FINAL ENVIRONMENTAL IMPACT REPORT
COMMENTS AND RESPONSES

**SISTERS OF THE HOLY NAMES
OF JESUS AND MARY
100 PROSPECT AVENUE
LOS GATOS, CALIFORNIA**

SUBDIVISION APPLICATION M-13-003
ENVIRONMENTAL IMPACT REPORT EIR-13-002

FEBRUARY 2014

FIGURE 8-3

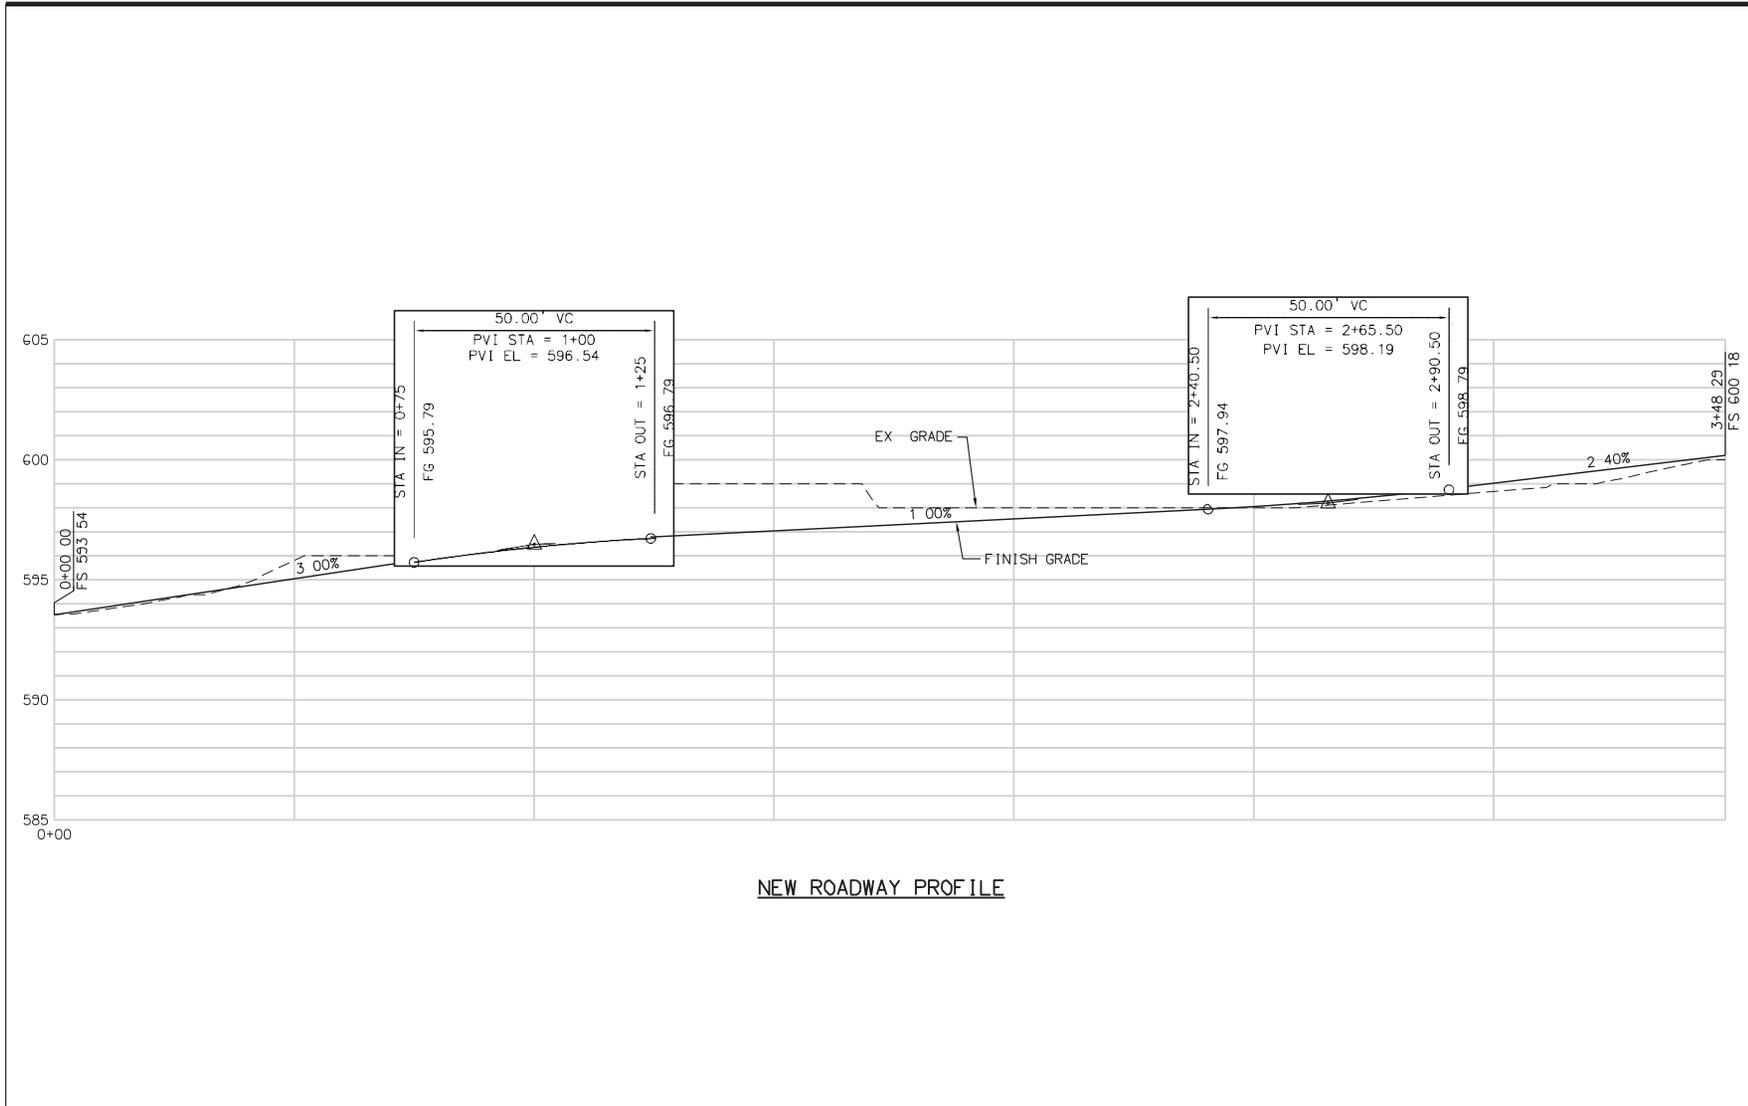
The proposed location of the Southern Cul-de-Sac opposite our driveway creates several impactful challenges. If the new street was created in alignment with an existing street such as Kimble Avenue it would have a lesser impact on the neighbors. *Proposed Vesting Tentative Tract Map, Figure 3.3, page 50*

1) The run off from this steep downhill paved street flows directly into our yard and into our paved down sloped driveway which will flood our garage. The proposed drains on either side of the street will not catch a sufficient amount of water to prohibit a severe impact to our property. *Conceptual Grading and Drainage Plan and C.3 Stormwater Conceptual Plan; Figures 3-4, page 52 and 3-6, page 55*

Response to Comment I_MacDonald-1: See Section 8.2 above for a description of the modified project, which realigns the southern cul-de-sac so that it is opposite Kimble Avenue. Also see response to Comment I_MacDonald-3 below for a discussion of the driveway location that was indicated in the DEIR project.

Response to Comment I_MacDonald-2: As a result of the drainage improvements proposed by the project applicant, the post-project condition would be an improvement from the existing condition, where drainage is permitted to overflow onto Prospect Avenue. The project has been designed in conformance with C.3 requirements and regulations such that runoff from the proposed cul-de-sac would be redirected through crowning of the cul-de-sac and then captured through a combination of curb openings, grates, swales and other retention and filtration systems prior to reaching Prospect Avenue. The proposed drainage system has been designed and sized to accommodate runoff generated on the project site. The proposed drainage system has been designed and sized to accommodate runoff generated on the project site and would not increase runoff onto the MacDonald property. Flow calculations were submitted to the Town of Los Gatos. The Town of Los Gatos Engineering and Public Works Department has reviewed and approved the preliminary design and calculations. The Town of Los Gatos also engaged third party drainage and C.3 experts and consultants to peer review the plans. Consultants at EOA, Inc. have reviewed the plans and confirmed that the design and sizing is appropriate for site runoff (see Appendix E of the Draft EIR). Conditions of approval will be included to require implementation of the design as approved by the Town.

Despite the DEIR project's less-than-significant drainage impacts with implementation of C.3 requirements, the modified project would relocate the cul-de-sac and the above drainage improvements to the Prospect Avenue/Kimball Avenue intersection, approximately 150 feet to the south. With proposed design change, project-related decreases in surface runoff from the site would be reduced even further. The project's flow calculations have been updated to reflect this new location and the updated Stormwater Management Plan is attached as Appendix L of this report.
